HISTORIC PRESERVATION COMMISSION
Regular Meeting
AGENDA

February 13, 2014 – 6:30 p.m.

DATE: 6/1/12

PROJECT ADDRESS: La Dolce Vita
107 Stephen St.
Lemont, IL 60439

SHEETS REVIEWED: 3 undated, hand drawn, letter sized plans labeled "Profile of
Awning", "South Elevation" and "East Elevation".

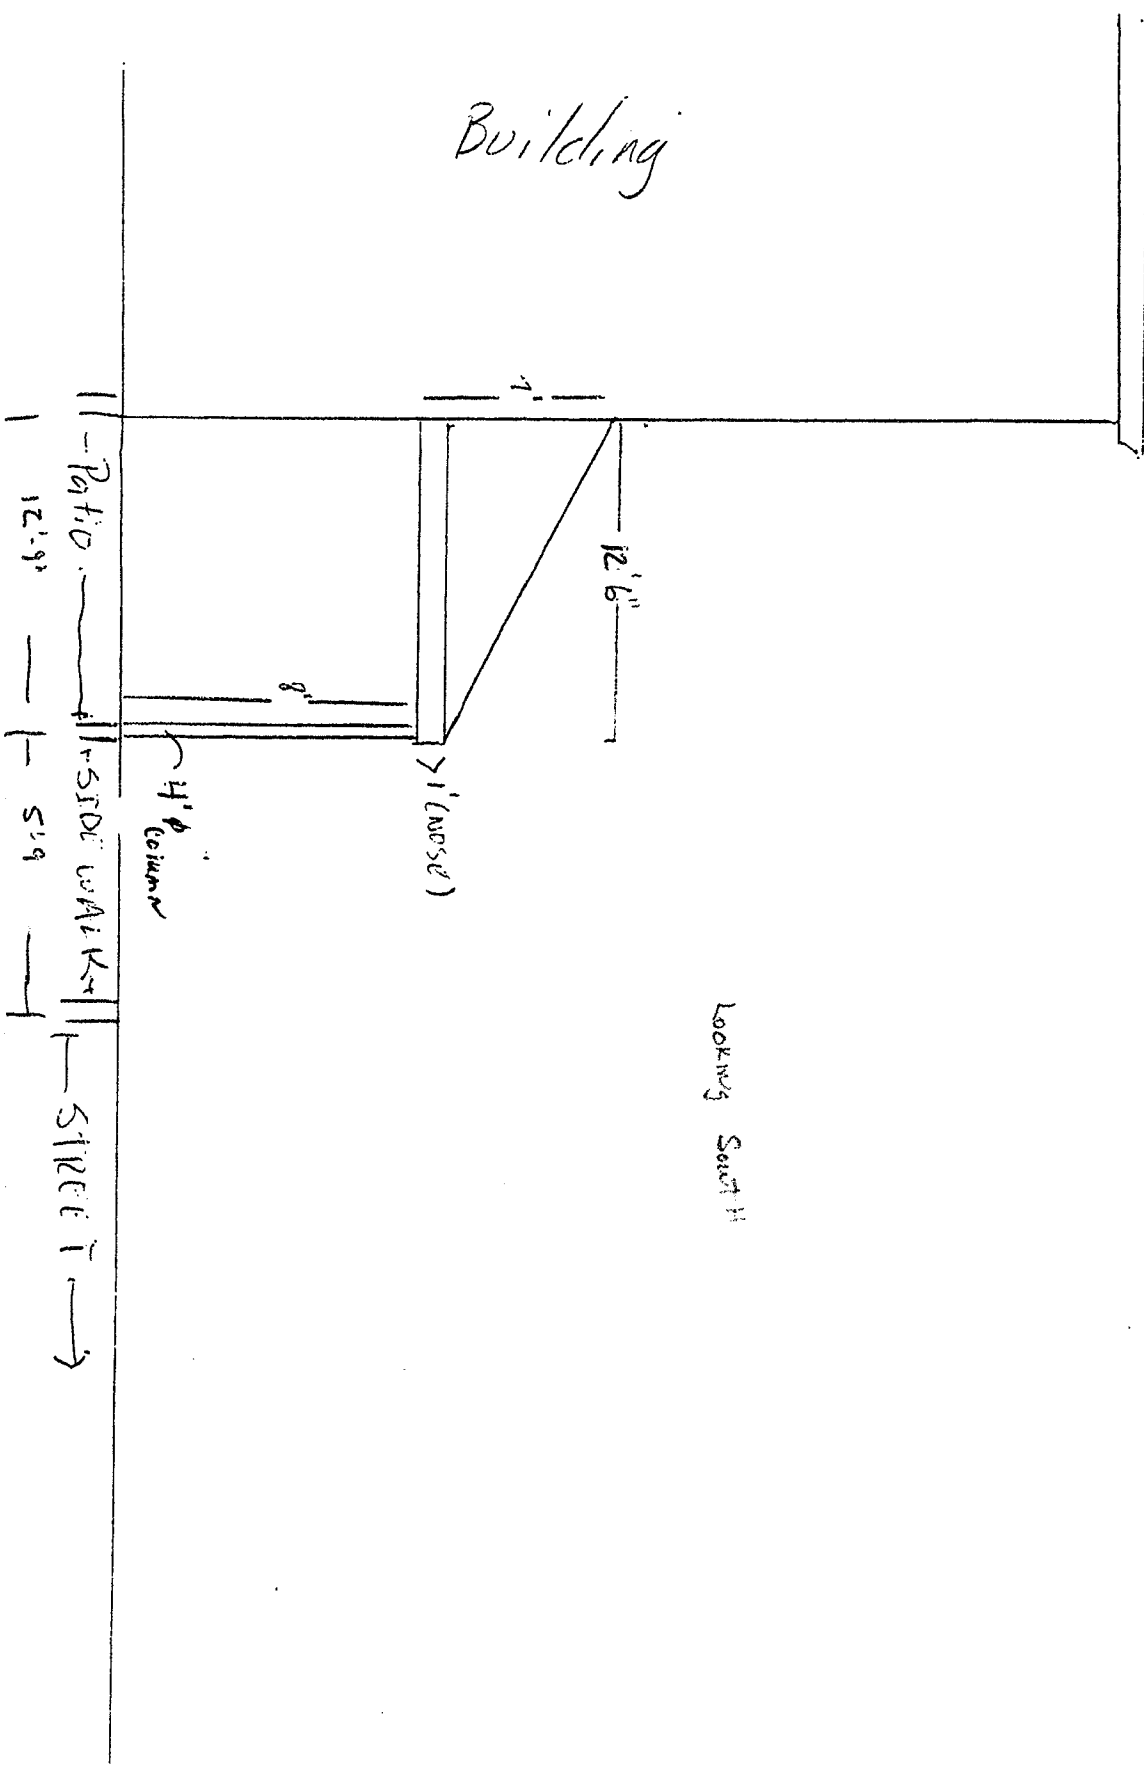
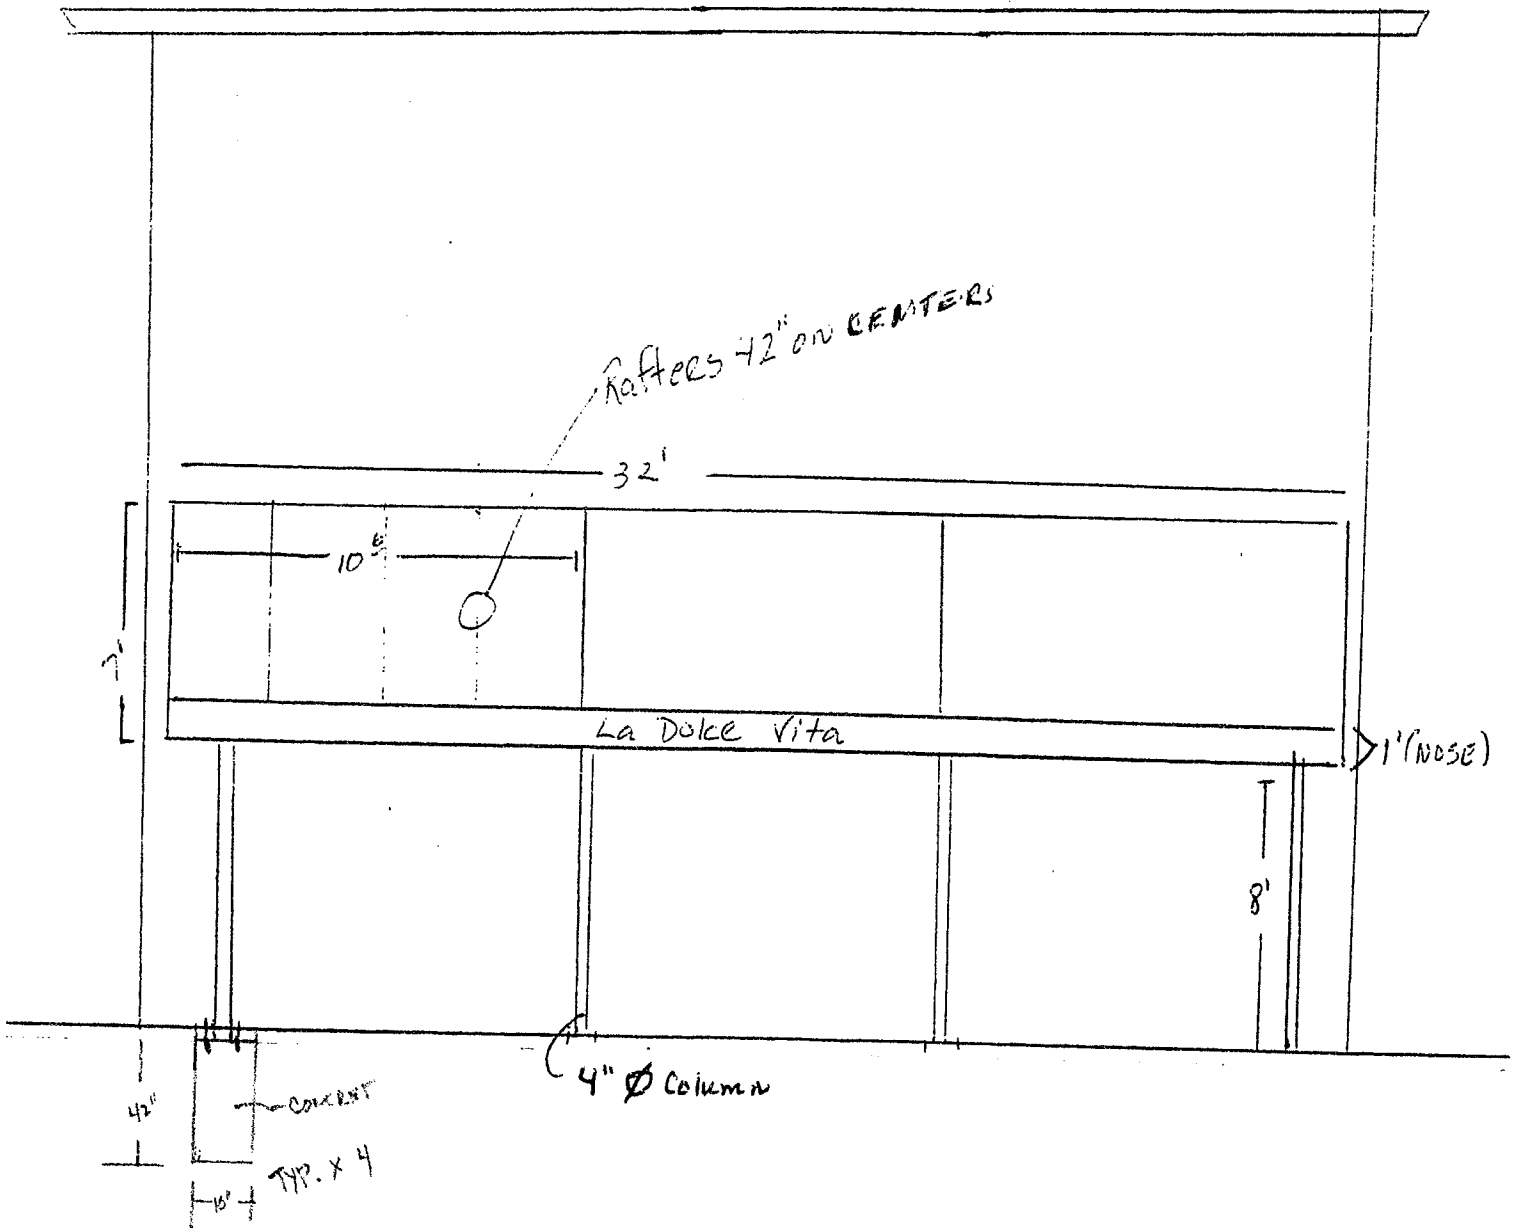
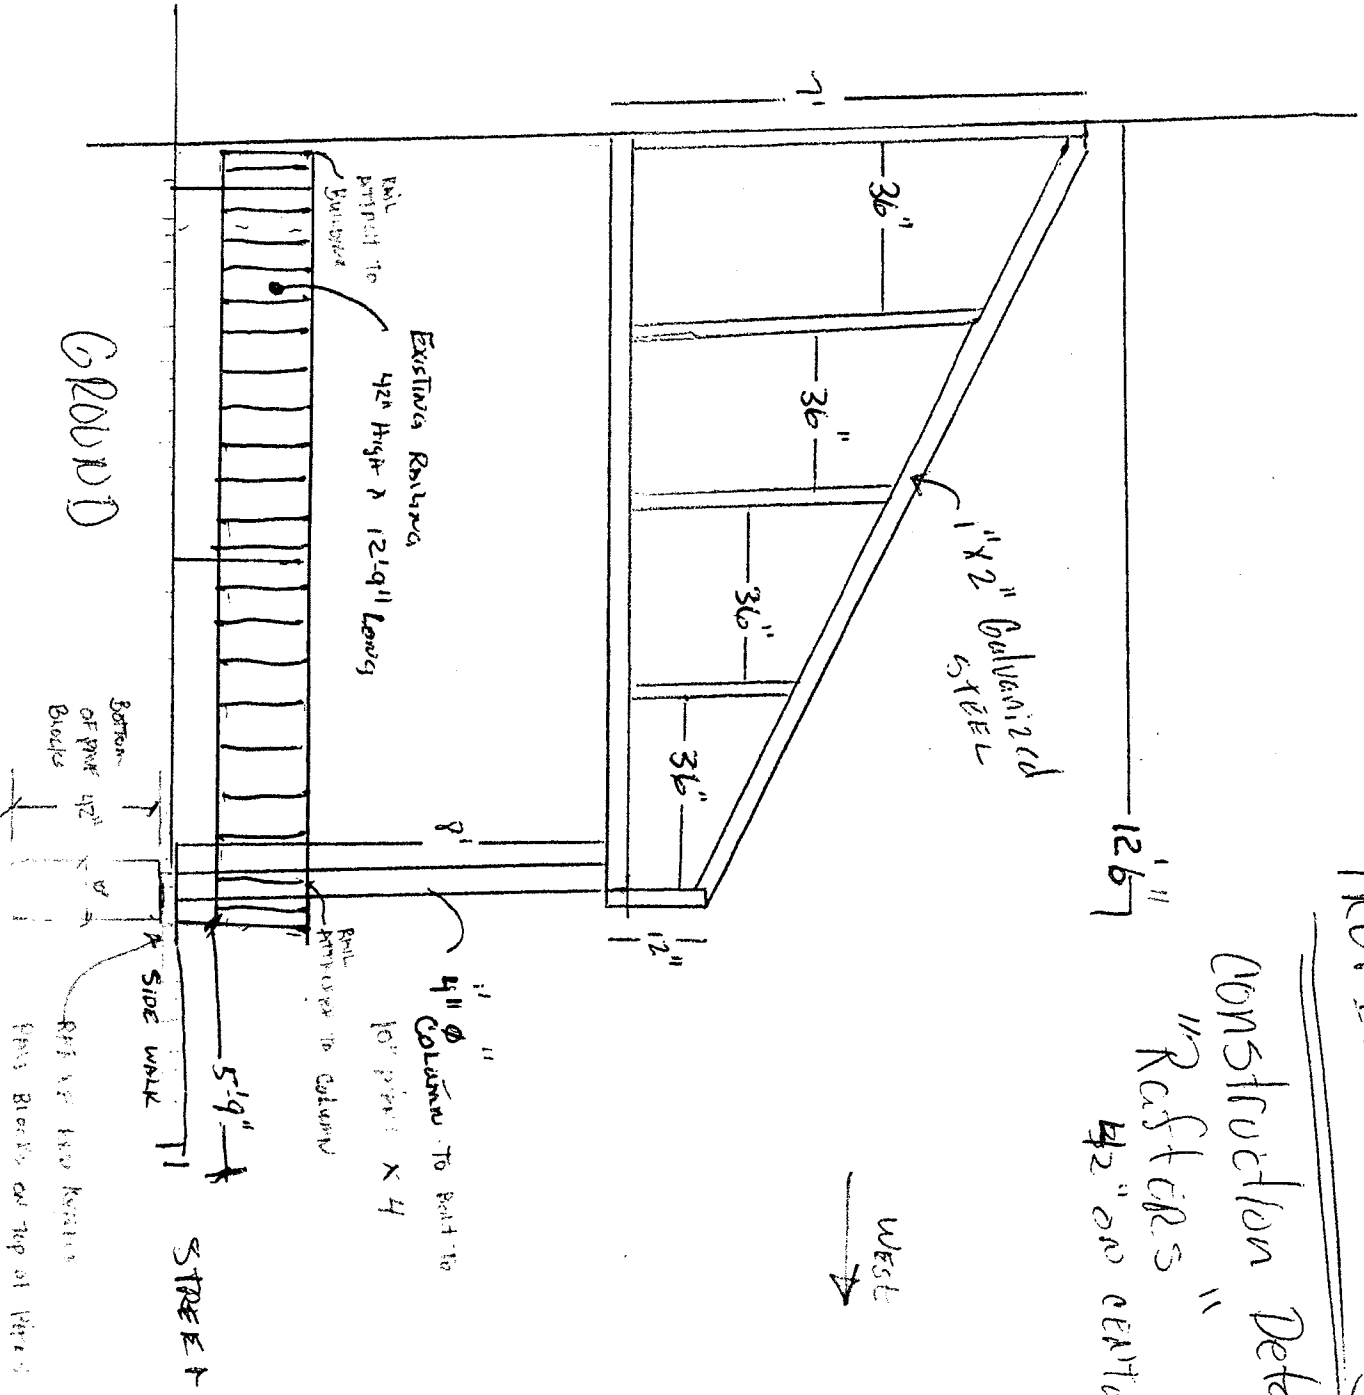
2. Note: The plans identify an open sided canopy. As such, side panels or other means of enclosing the underside of the canopy may not be done without further, additional permit submittal, review and approval. (Section 105.1) (Note only. Response not required.)

3. Provide structural plans and calculations signed and sealed by an approved Illinois registered/licensed architect or structural engineer identifying, in part, that the canopy structure as proposed meets the wind, snow, lateral and live load requirements of Chapter 16. (Sections 106.1, 106.1.1 and 3105.3)

4. Provide details on the attachment of the awning structure to the building and to the 4" posts. (Section 106.1.1)
5. Provide details on the type and size of beam supporting the front of the canopy structure on the columns. (Section 106.1.1)

6. Identify the type of 4" columns to be used. (Section 106.1.1)
7. Provide details on the awning covering/membrane including documentation identifying that the covering material meets the fire propagation performance criteria of NFPA 701 or has a flame spread index of no greater than 25. (Section 3105.4)

54" tall x 27' Awning

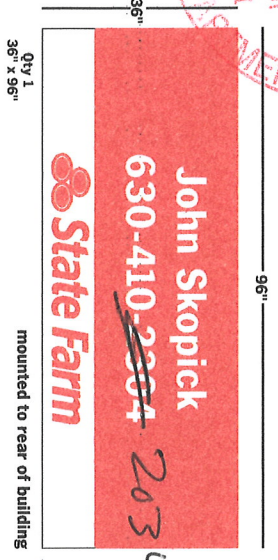
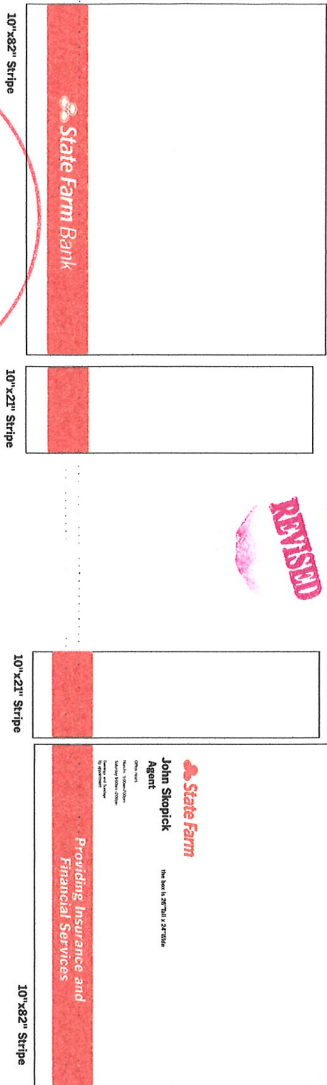
so it would qualify as one sign. Discussion addressed the rear wall sign. Mr. Batistich commented that the sign as shown is too close the windows, obscuring the soldier course of bricks over the lower window. He suggested a smaller sign which would also resolve the issue of the overall sign allowance. State Farm allows a 24' x 96' sign which may better suit the space available. Mr. Schwartz suggested re-locating the sign to be centered on the building, beneath the middle two of the 4 upper windows. The Commission agreed that it would be a better fit for the building. Motion by Mr. Batistich, seconded by Mr. Cummins, to approve a Certificate of Appropriateness with the following recommendation: Due to conflict with windows, wall sign on the south façade to be re-sized to 24" x 96" and centered on the building, and with modifications to window signs as required by the UDO. Voice vote: 5 ayes. Motion passed.

This Certificate approves replacement awning, 54" x 27' in State Farm Red with logo and text as indicated on application; window signs on north facade with modifications as required by the UDO; and due to conflict with existing windows, a wall sign on the south facade, recommended size 24" x 96" and centered on the building under middle 2 of 4 second story windows with logo and text as indicated on the application materials submitted and dated 12/5/2013 and 12/12/2013.
